# Rezoning Transportation Analysis

Petition Number: 2018-056

General Location Identifier: 0319115

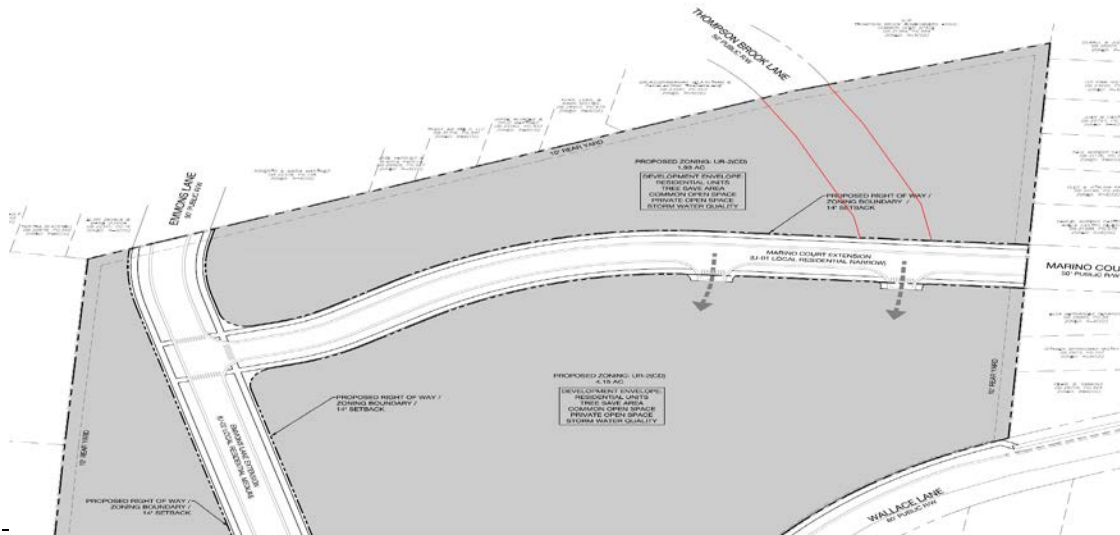
**Curbline** The proposed zoning district has a setback measured from back of the existing or proposed future curbline. The location of the back-of-curb is to be set 17.5' from centerline.
